EO - Installation des BearPaws avec le Float Kit

Title:						EO#:		
Rework of Aft Attach Clamp - BP350 BearPaw Installation					HTS-EO-0709-001 Rev NC			
DI 550 Bomi aw histanation						1113-EO-0709-001 Rev NC		
n w								
Prepared by:		Design:	Mech:	Stress:	Approved:	Date:		
11	HAA					MITTE		
Mirko Zgela		N/A	N/A	N/A	Mirko Zgera	April 24, 2008		
(DAR #310)					(DAR #3/10)	7 spin 24, 2000		
					(3740)			
Registration: S					ıl:			
A/C Effectivity:		C-GSOA 4363						
Reference Documents:								
[a]	Doc # - HTC-314-0020-00-B, "BearPaw Model BP350 - Installation Instructions -							
	AS350/355 Series Helicopters", Rev B, dated Jan 29, 2007							
	Drawings:							
[b]	#112-0002-00, BearPaw BP350 - Assembly, Rev B, dated Nov 20, 2006							
	#VNR107, BearPaw BP350 – U Shaped Clip, R01, dated Sept 29, 2006							
Dagger				- Jimpou Ci	1p, 1001, u	area Bept 23, 2000

BearPaw Model BP350

Figure 1 - Clamp Interference with Aft Fitting

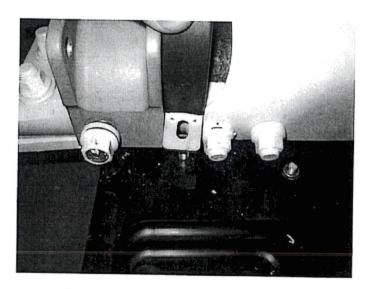
When the BearPaw are fitted to AS 350 helicopters equipped with the Aerazur (Zodiac) emergency floatation system the rear attach fitting interferes with the aft clamp on the BearPaw as shown by Figure (1).

In order to fit the BearPaw when the Aerazur (Zodiac) emergency floatation system is installed perform the following:

Rework Instructions:						
1	Move the BearPaw slightly forward so that the BearPaw pad rear attachment hole is centered between the flotation system aft fitting and the rear cross tube aft bolts					
2	Trim the U-Shape clip (P/N 314-0019-15) by approximately 0,0625" on each side to reduce the width of the clamp to remove the interference with the cross tube aft bolt. The U-Shape clip will mount on the rear cross tube saddle.					
3	Elongate the BearPaw rear attachment hole outboard to align the U-Shape clip hole with the BearPaw hole.					
4	Take photographs of the rework aft U-Shape clip installation and provide the following to Helitowcart: - BearPaw elongated hole final dimensions; - Final width of the U-Shape clip; - The distance that the BearPaw had to be moved forward.
